Addendum No. 2

Bear Creek Redwoods Public Access Project

Date: April 3, 2018

Drawn by : ARS
 Checked by : RLC
 Drawing Title :
**SIGNAGE,
 STRIPING, AND
 PAVEMENT
 PLAN-PARKING
 LOT LAYOUT**
 Date : 2/6/18
 Scale : AS SHOWN
 Project Number : 16.04
C3.0
 Sheet Number :

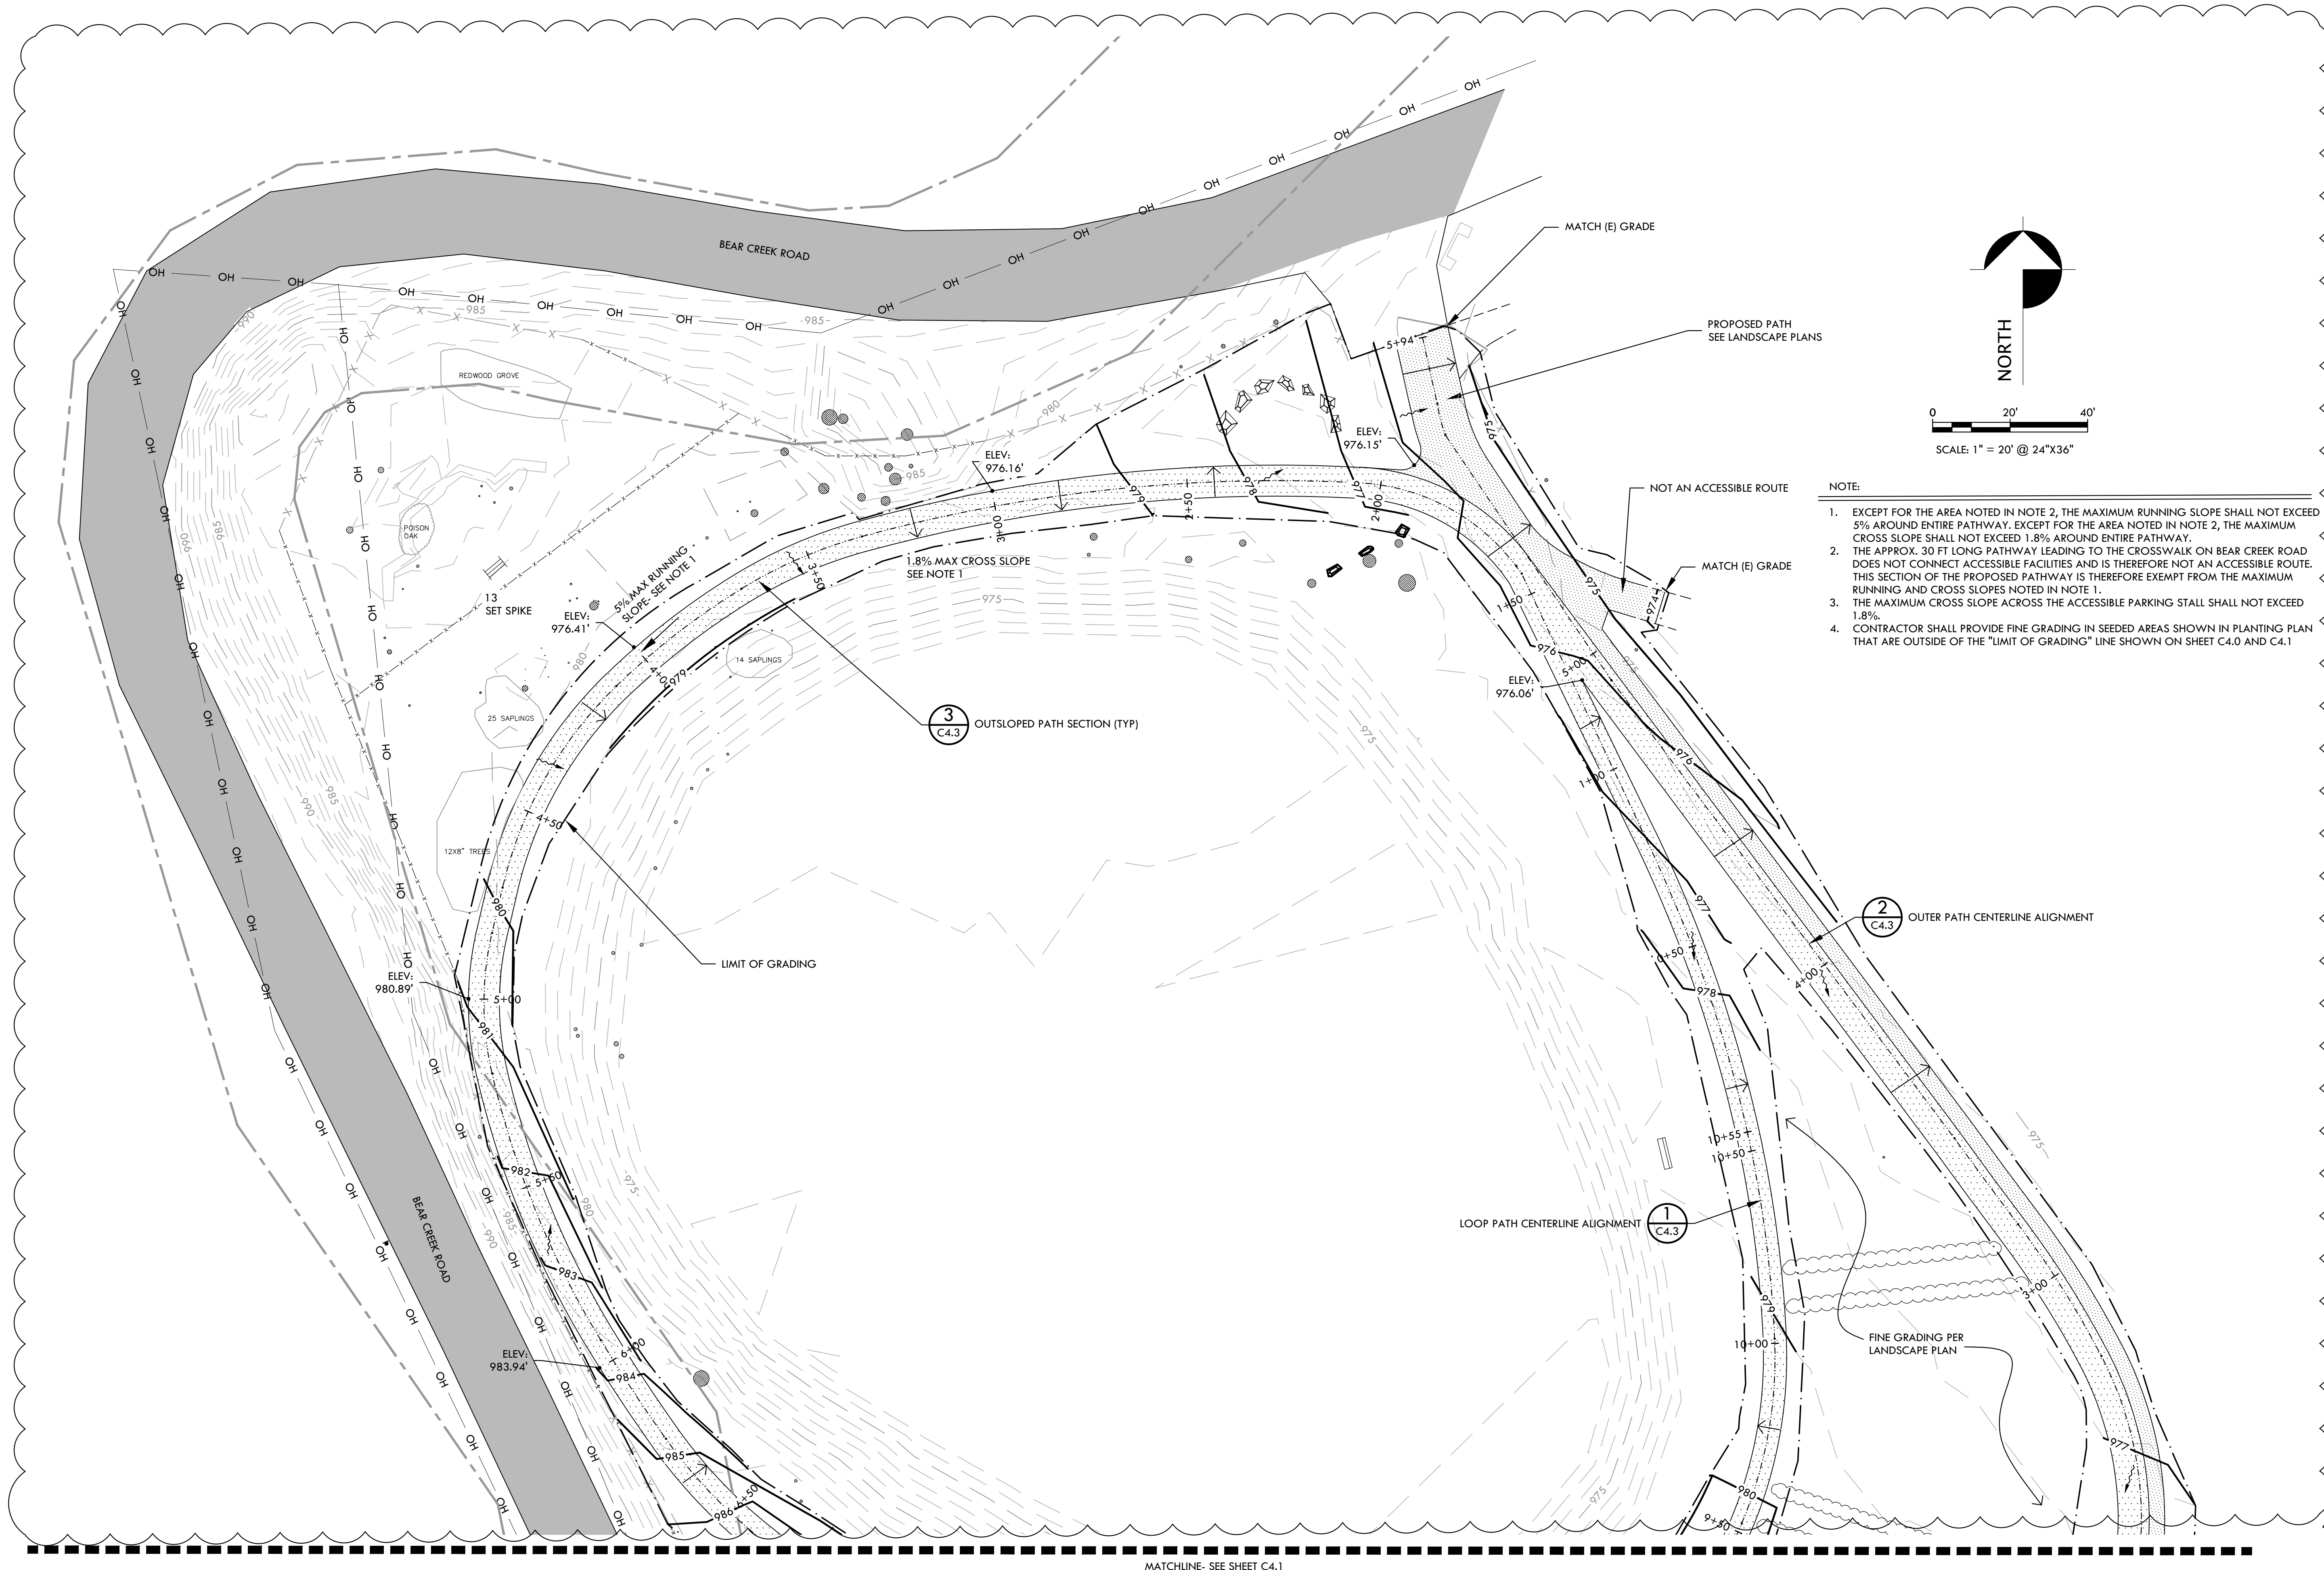
- a. Replace existing Sheets C3.0, C4.0-C4.4, C5.0, L2.2, L5.1, and L5.4 with attached revised sheets.
 - i. C3.0 – Changed striping and stall notes
 - ii. C4.0 – 4.4 – Changed grading near concrete stairs, added enlargement detail of stairs, added spot elevations throughout, added note regarding culvert location and protection in places, minor revisions to sections and profiles.
 - iii. C5.0 Revised pond overflow detail.
 - iv. L2.2 added truncated domes along north edge of parking lot
 - v. L5.1 revised Detail 4, truncated domes
 - vi. L5.4 revised Detail 1 and Detail 3 to add a 4th bollard and associated striping.

Sheet Number : C4.1

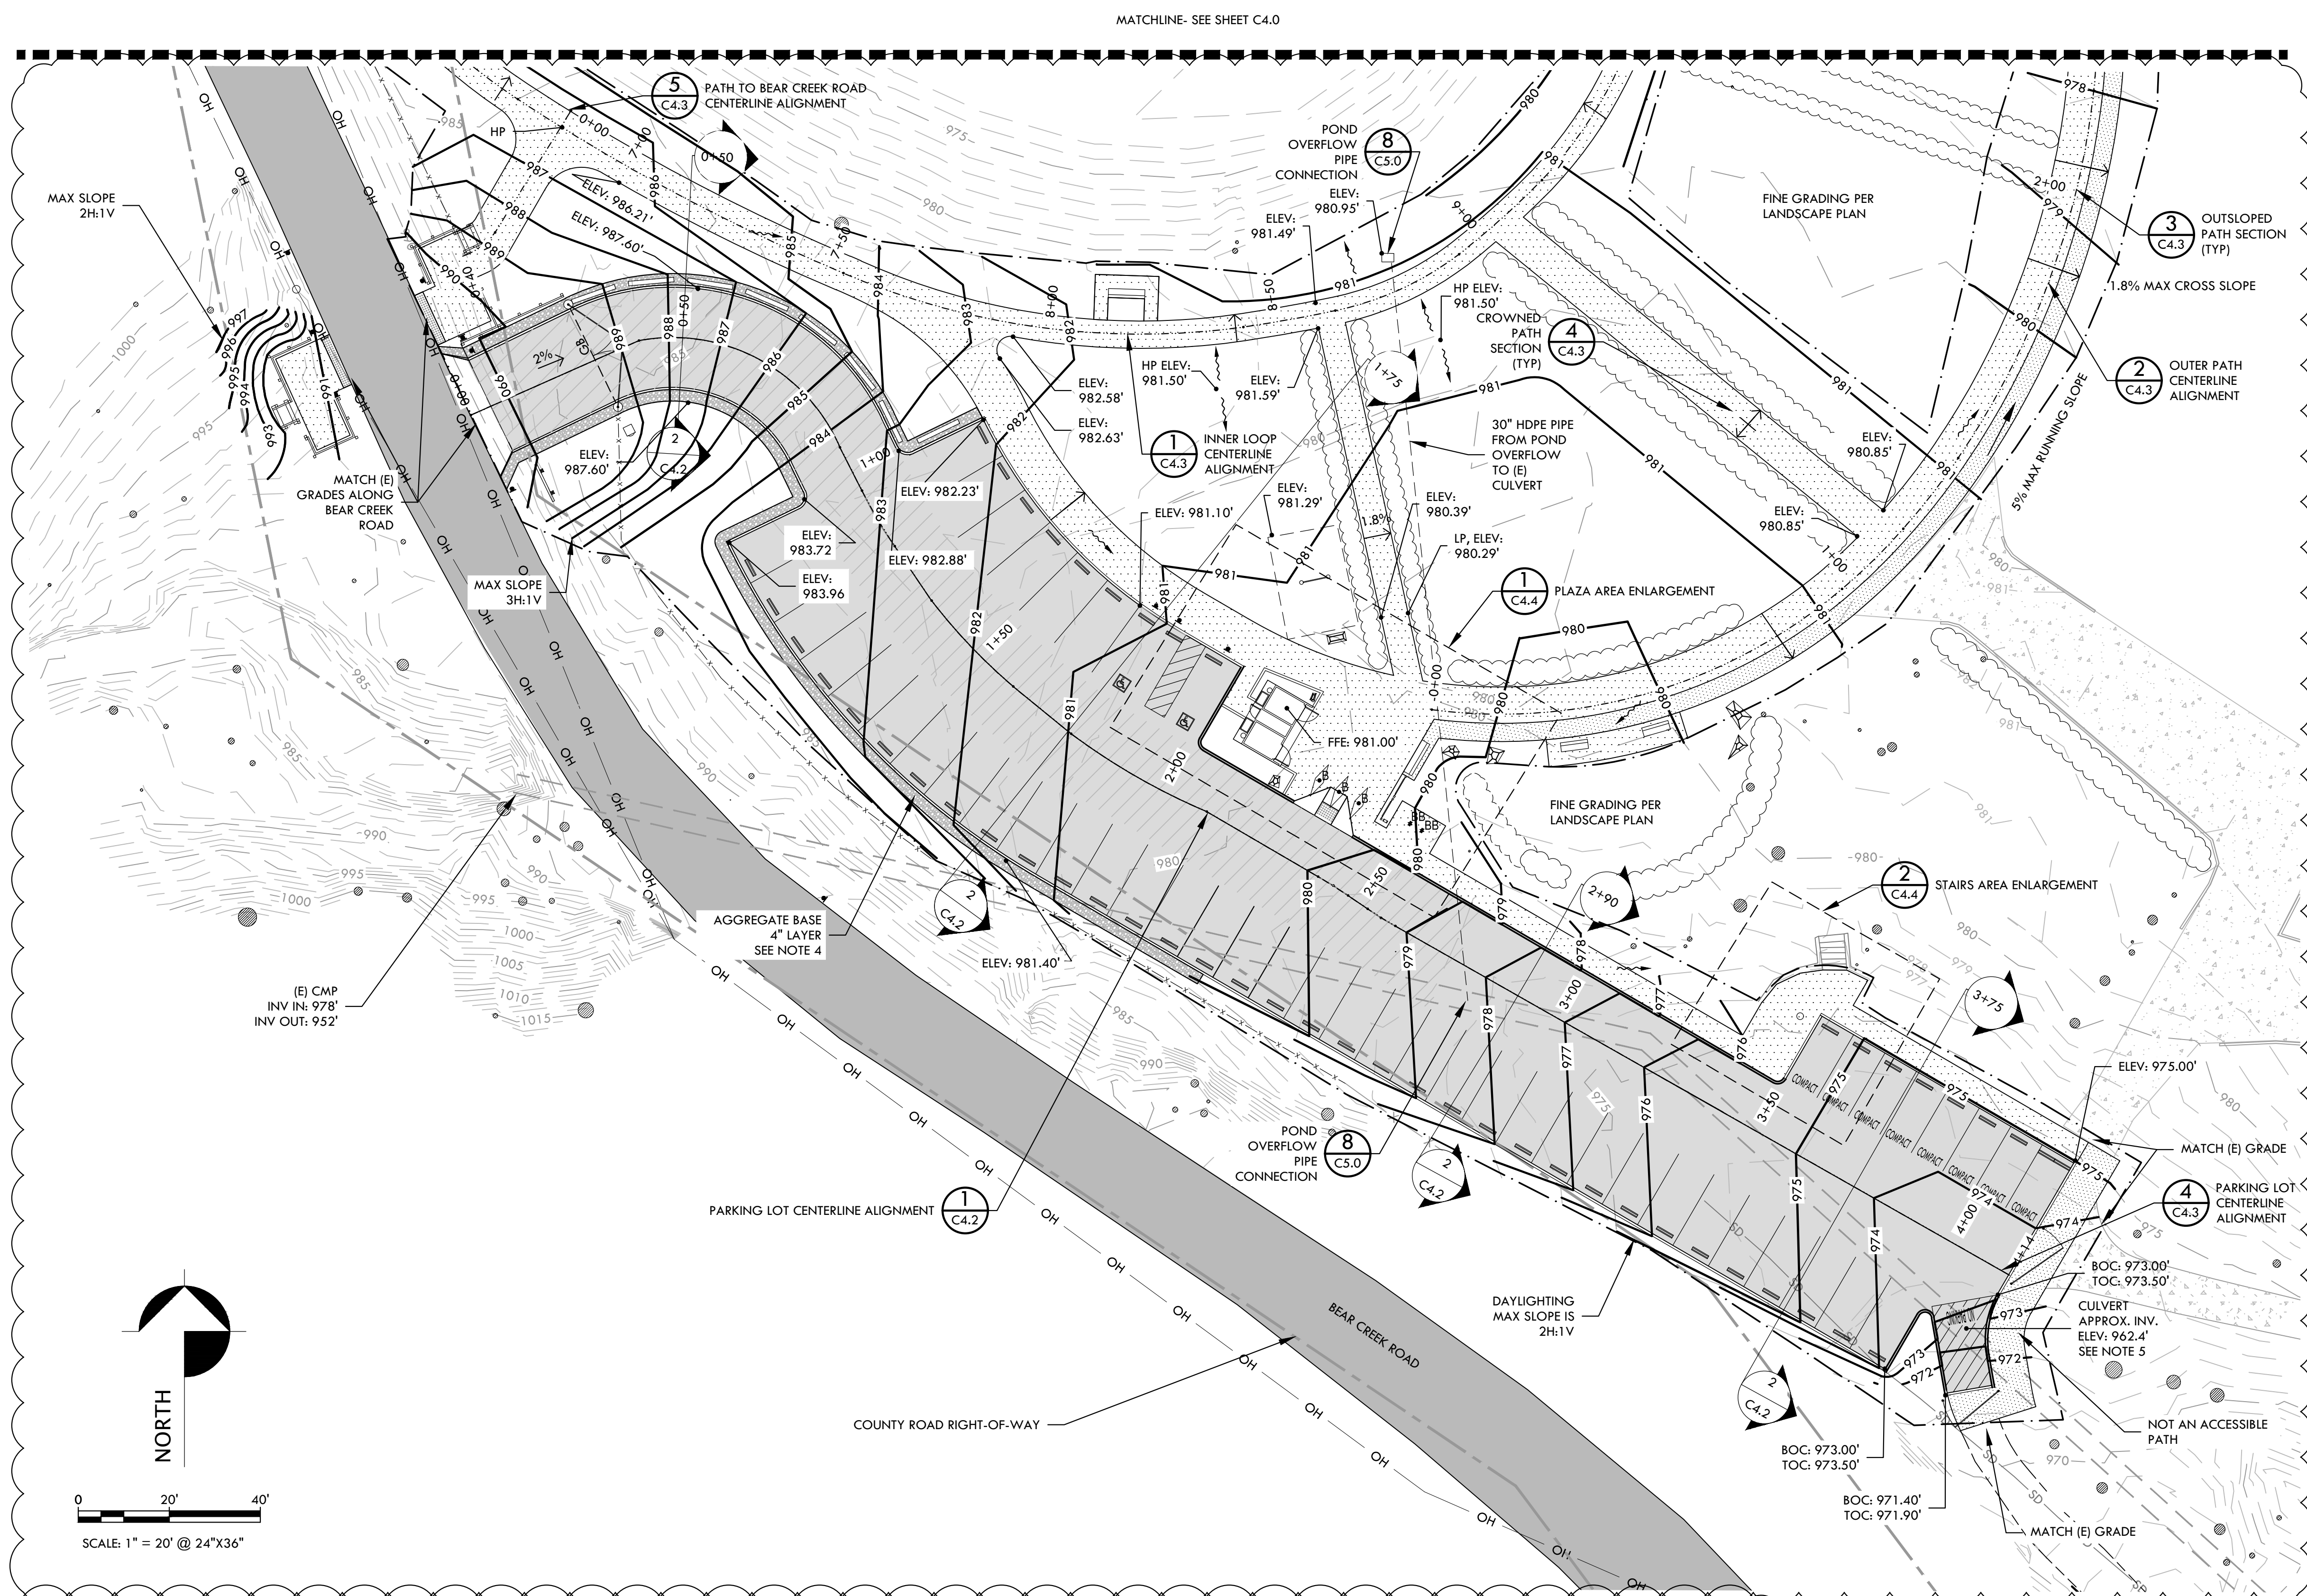
- 10) Q: Is there a detail for the pond overflow? On Sheet C4.1 it says by others.**
A: This contract will only install a utility box at the pond end of the new pipe. The overflow inlet will be installed following this project in another contract.
